STATE OF VERMONT AGENCY OF TRANSPORTATION

PROPOSED IMPROVEMENT SAFETY PROJECT TOWN OF SPRINGFIELD COUNTY OF WINDSOR

PROJECT DESCRIPTION: PARTICIPATION: REPAIR AND REHABILITATION OF EXISTING METAL BINWALL ALONG LEFT SIDE OF TH 1, INSTALLATION OF NEW DRAINAGE AND SIDEWALK ALONG LEFT SIDE OF TH 325, COLD PLANING AND PLACING NEW BITUMINOUS CONC. PAVEMENT ON TH 325 .

RECORD PLANS

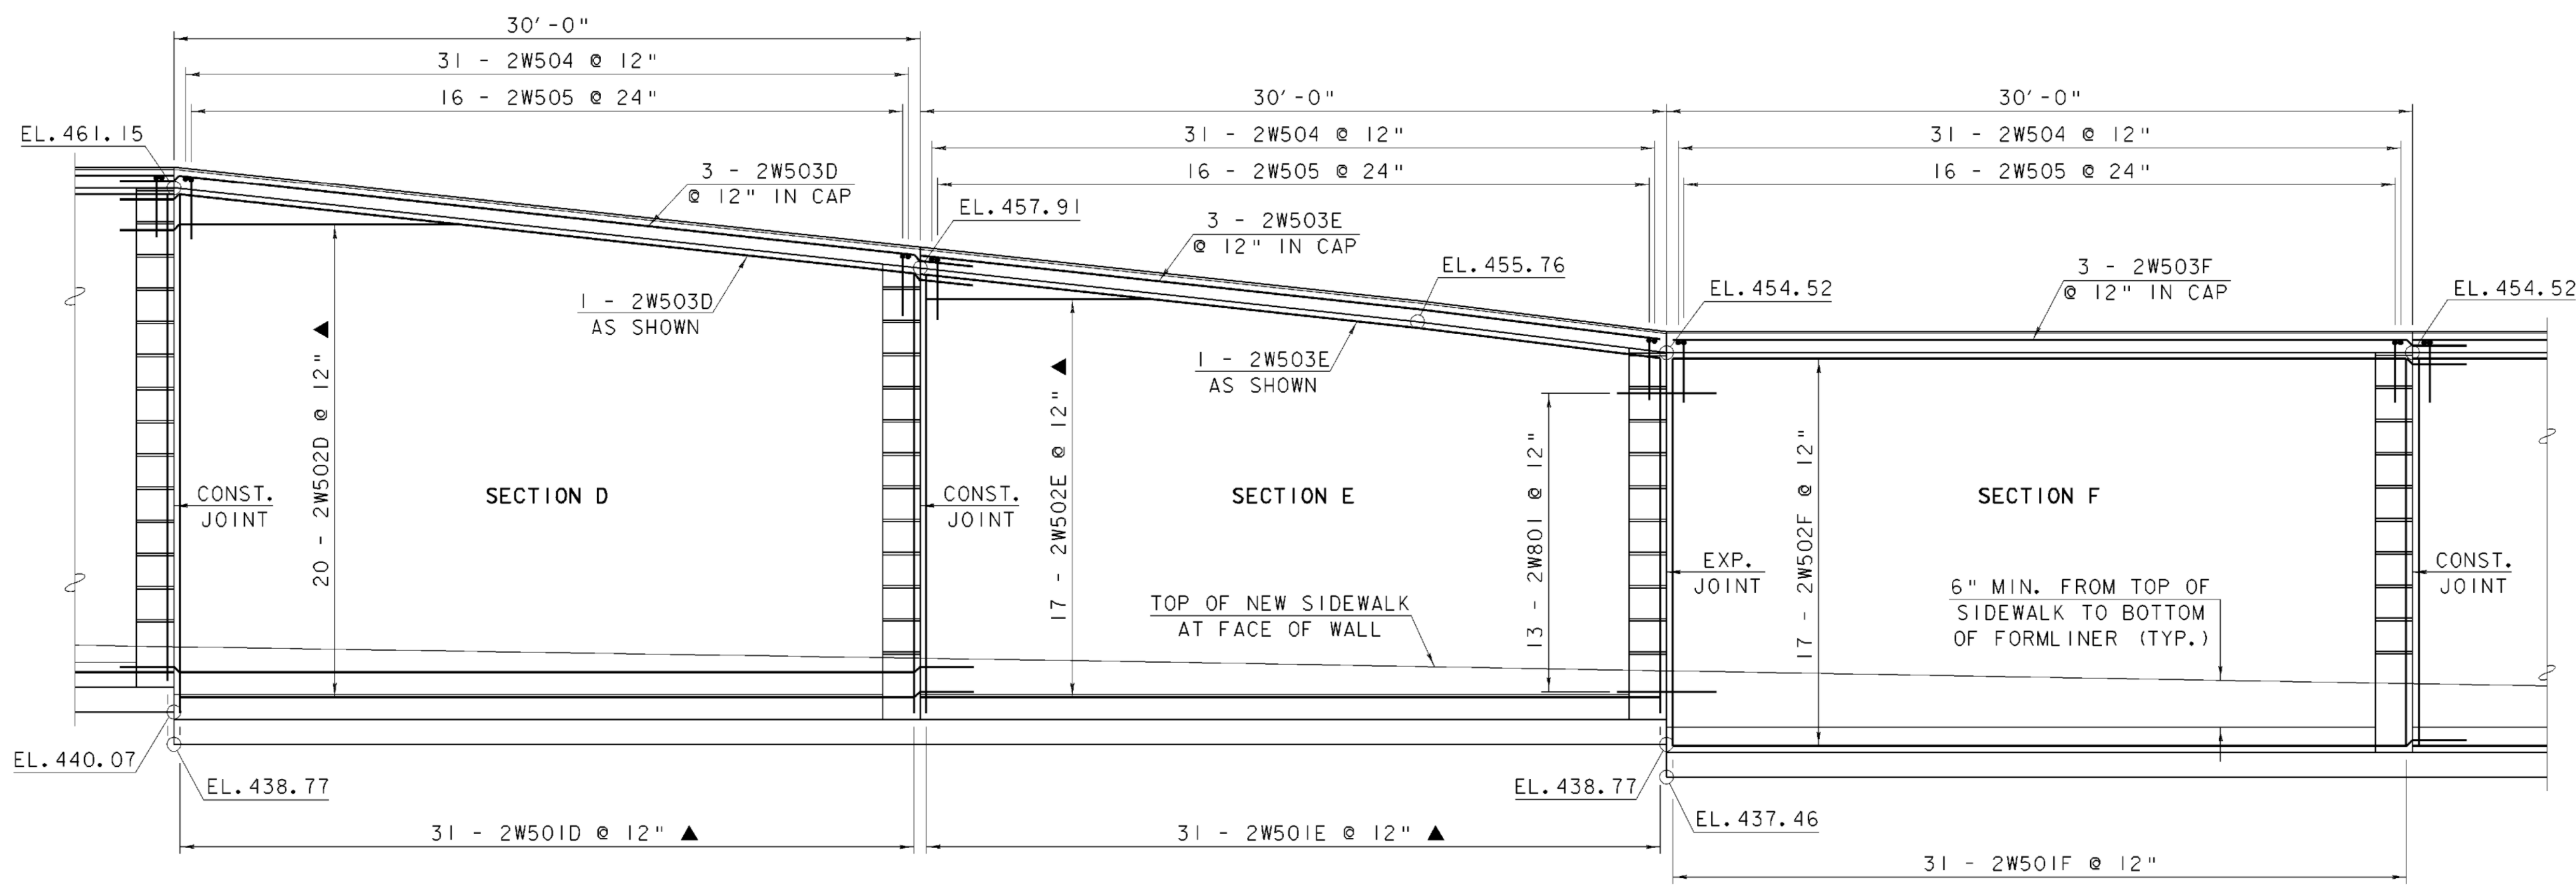
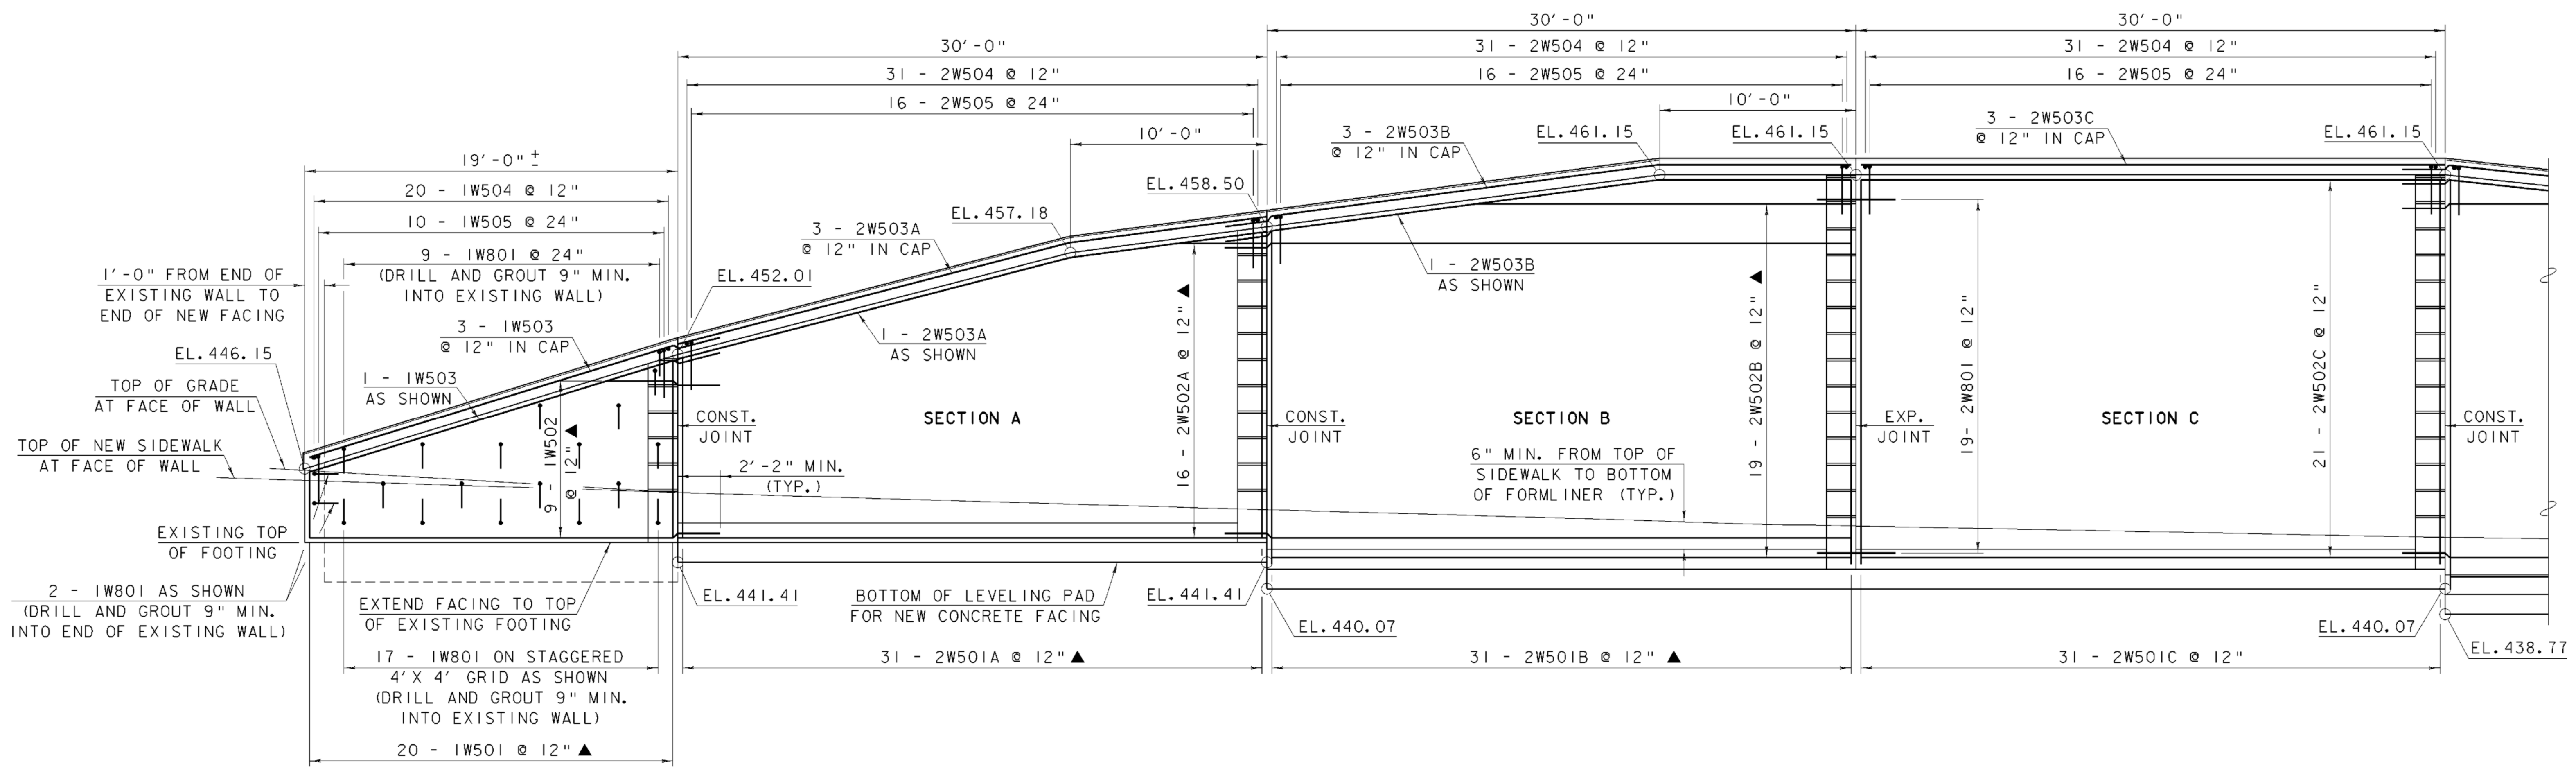
SEE REVISED ELEVATIONS IN
 VALUE ENGINEERING PLAN SET.

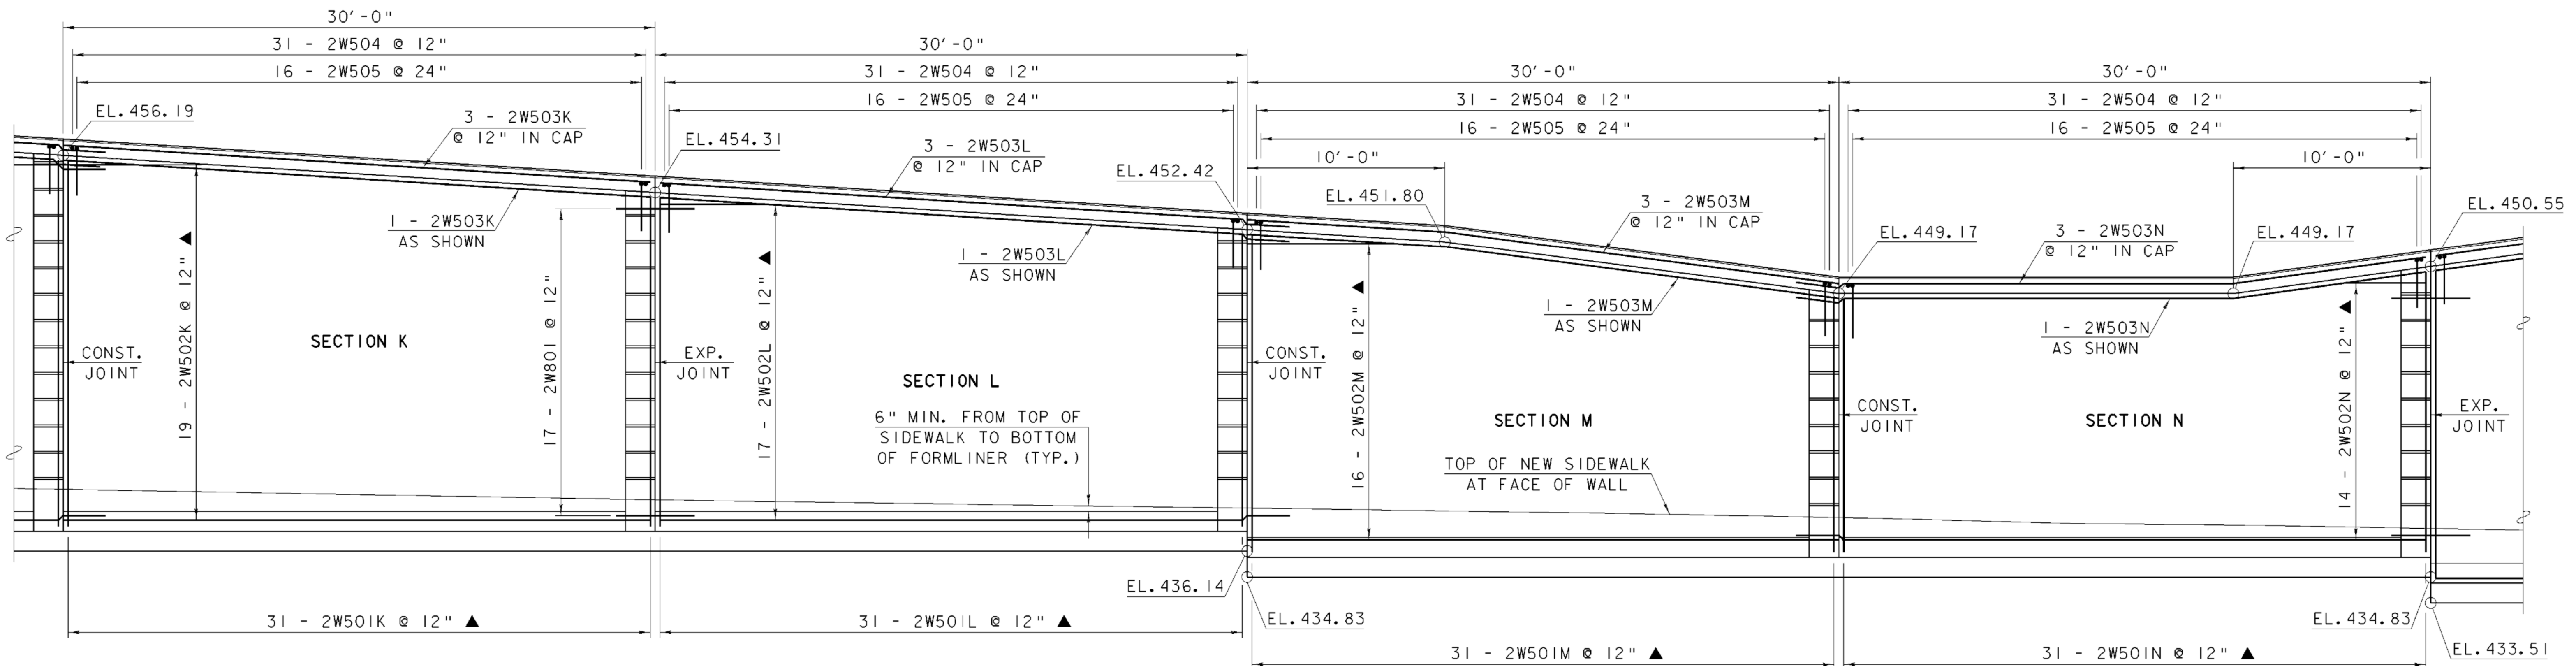
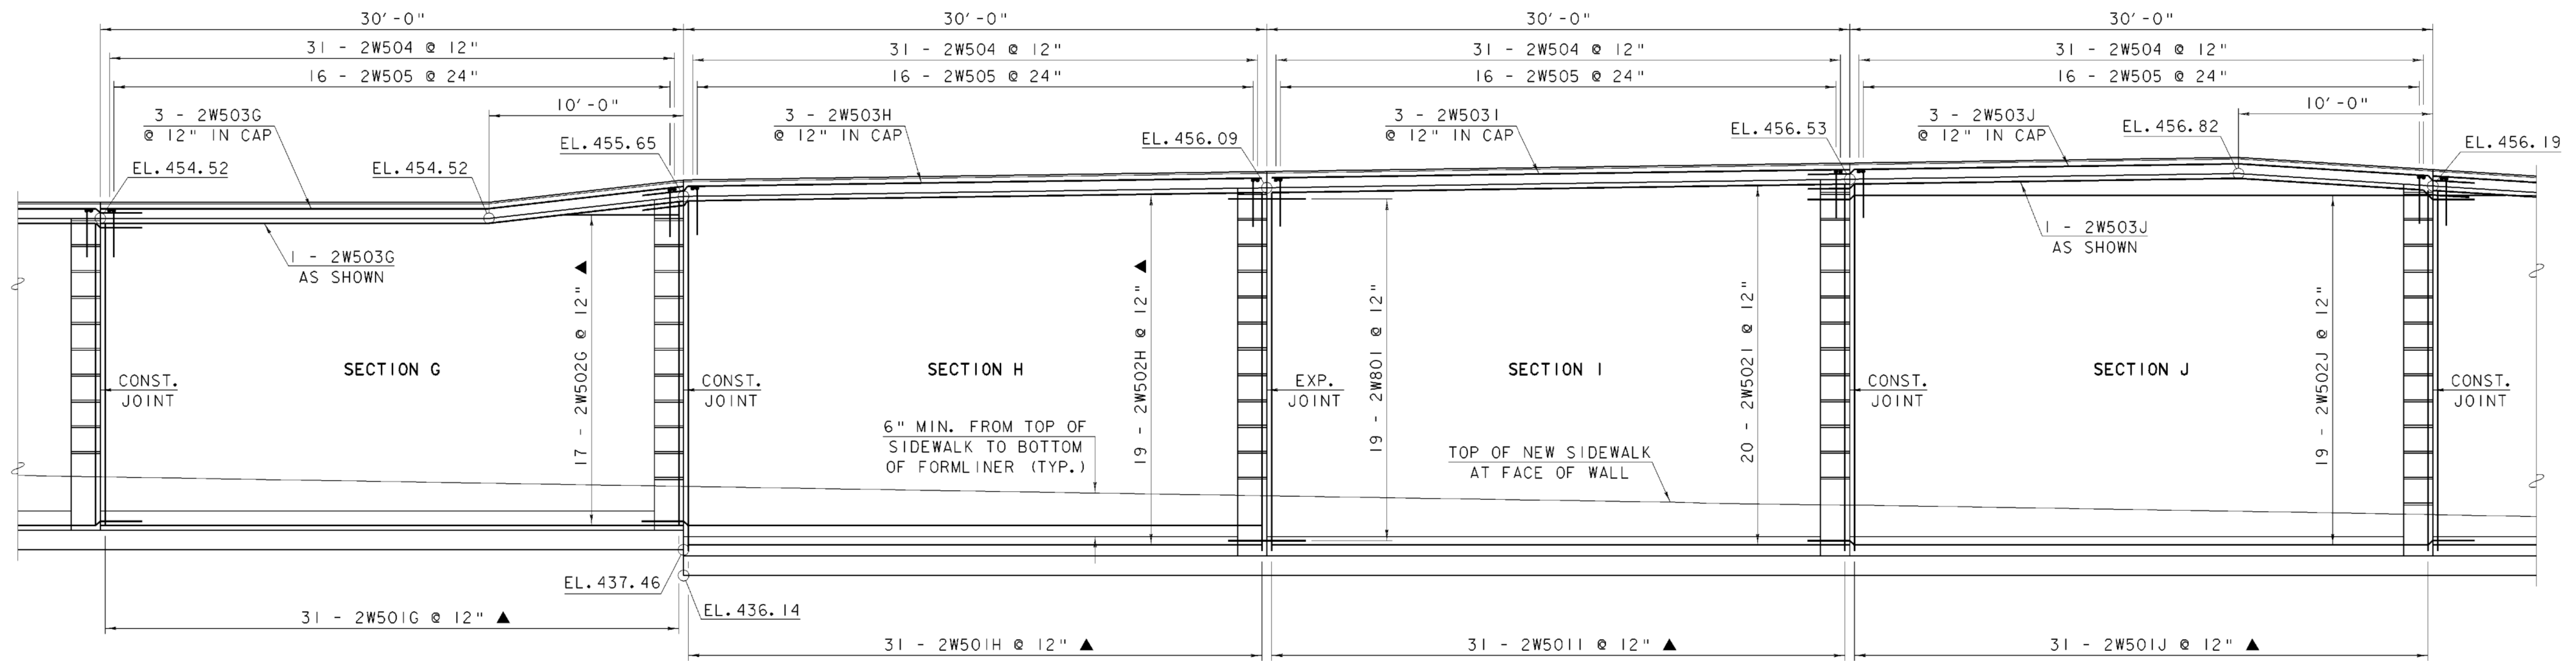
SEE REVISED ELEVATIONS IN VALUE ENGINEERING PLAN SET.

WALL ELEVATION (2)

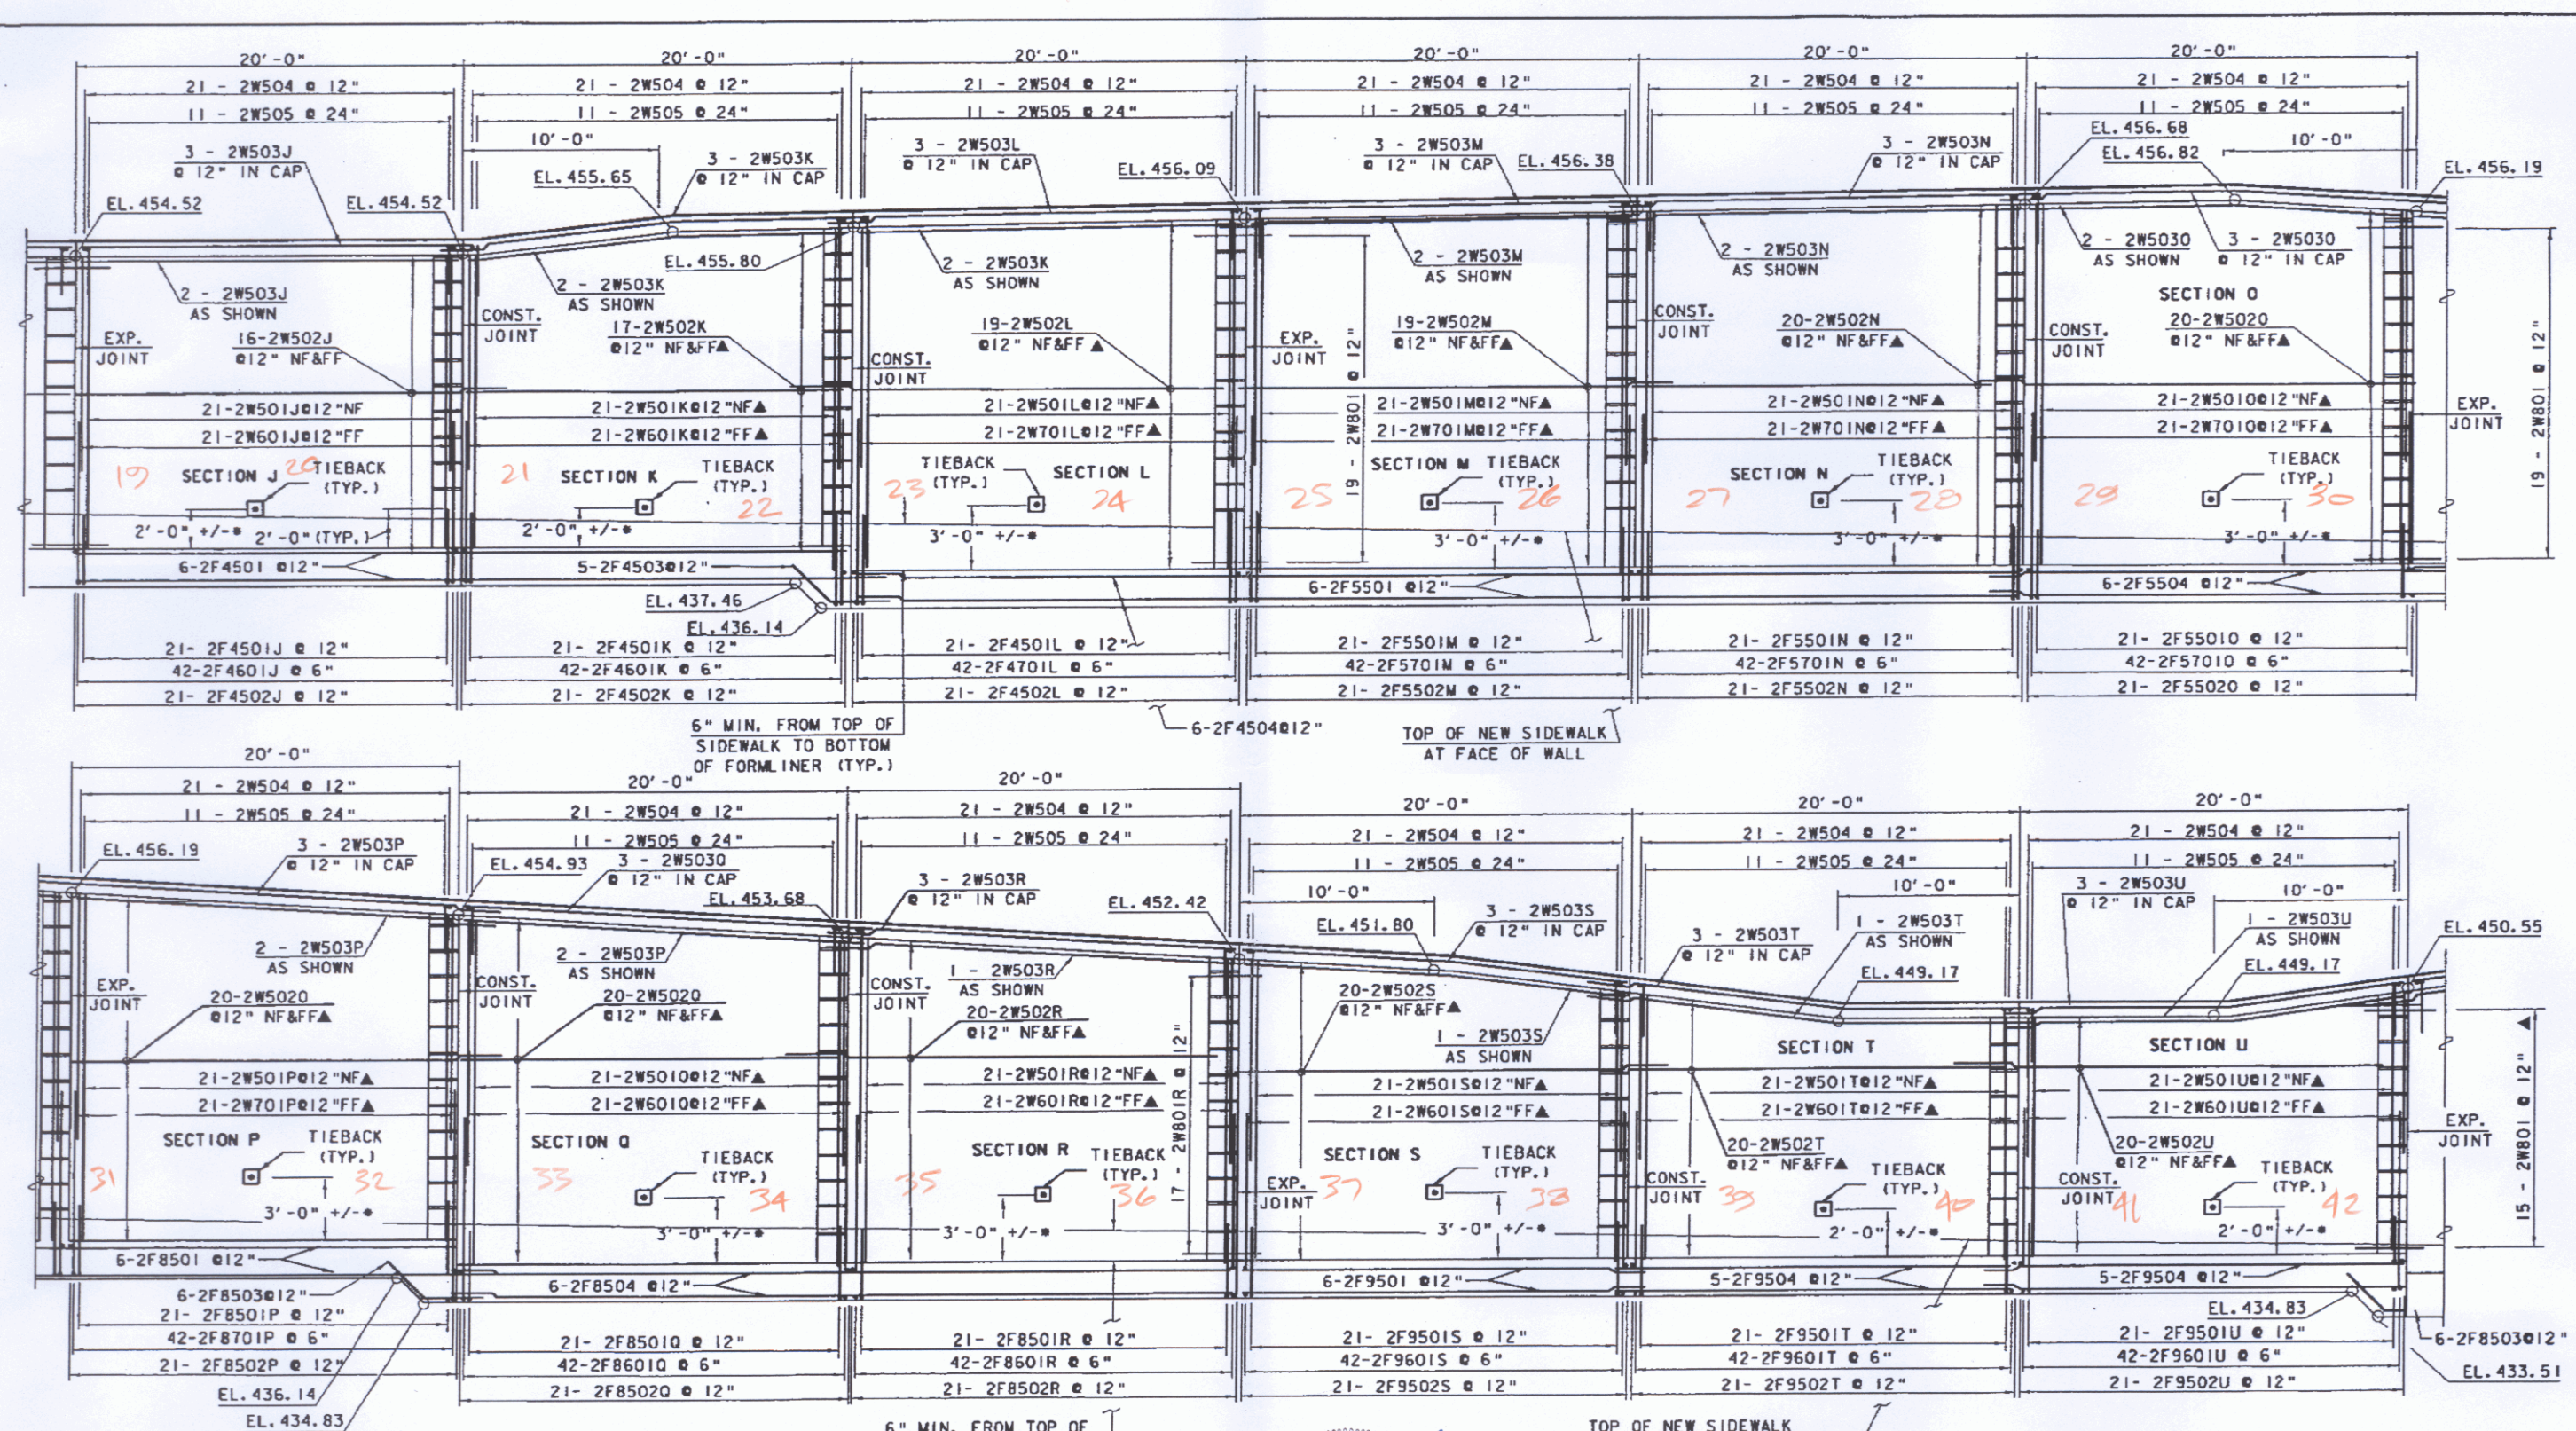
VALUE ENGINEERING REDESIGN
OF WALL 2 PREPARED BY
GEODESIGN, INC. 3-16-05

NOTE:
SEE SHEET 488 FOR ADDITIONAL
PUNCHING SHEAR REINFORCEMENT
AROUND EACH TIEBACK BOXOUT.
